Art Unit: 1773

8. Applicant's amendment necessitated the new ground(s) of rejection presented in this Office action. Accordingly, **THIS ACTION IS MADE FINAL**. See MPEP

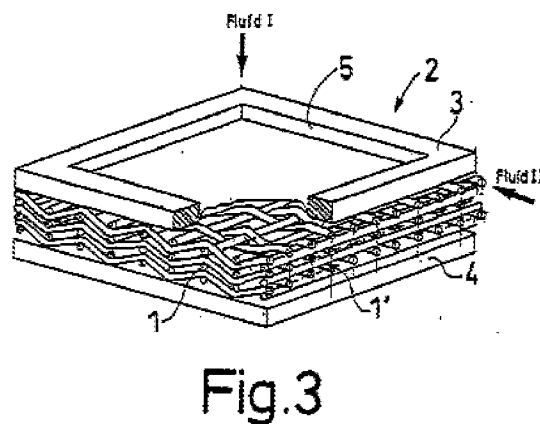
3. With respect to claim 1, Durst et al. teaches a upper frame part (3, fig. 1) (first supporting plate) and a least one capillary hollow fiber (1) (hollow filament) constituting the channel of the microfluid system, wherein the capillary hollow fiber (1) (hollow filament) is placed on the upper frame part (3) (first supporting plate) in any shape, and a particular internal region of the capillary hollow fiber (1) (hollow filament). With respect to “a function,” Durst teaches the use of the polysulfone fibers of Ly (4970034). Polysulfone is inherently hydrophobic [Ly, col. 3, lines 37-51] and inherently has the function of adsorption/desorption (Strano, 2003/0034295, [0095, 0128], Table F). Further, Durst teaches the movement of one component from one

4. With respect to claim 2, Durst et al. teaches more than one capillary hollow fiber (1) (hollow filament) are placed (fig. 1).

6. With respect to claim 4, Durst et al. teaches at least one capillary hollow fiber (1) (hollow filament) is placed crosswise to at least another capillary hollow fiber (1) (hollow filament; placed crosswise the capillary hollow fiber (1) (hollow filament) itself (fig. 1, fig. 3).

7. With respect to claim 6, Durst et al. teaches a lower frame part (4) (second supporting plate), wherein at least one capillary hollow fiber (1) (hollow filament) is held between the upper and lower frame part (3, 4) (first and second supporting plates) (fig. 1).

8. With respect to claim 7, Durst et al. teaches part of at least one capillary hollow fiber (1) (hollow filament) is exposed through at least one of the upper and lower frame part (3, 4)(first and second supporting plates) (fig. 1).

Fig. 4

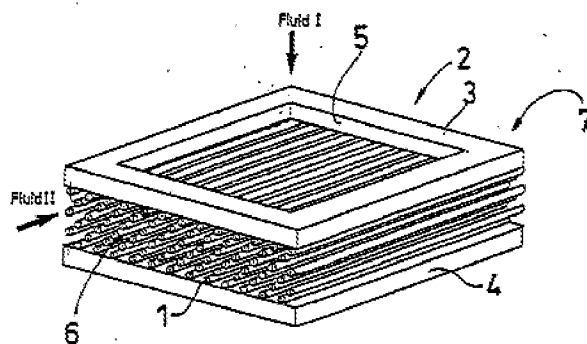
10. With respect to claim 9, Durst et al. teaches the inlet and discharge opening (5) (port) is fixed to (at least one of) the upper frame part (first and second supporting plates). See, e.g. Fig. 4.
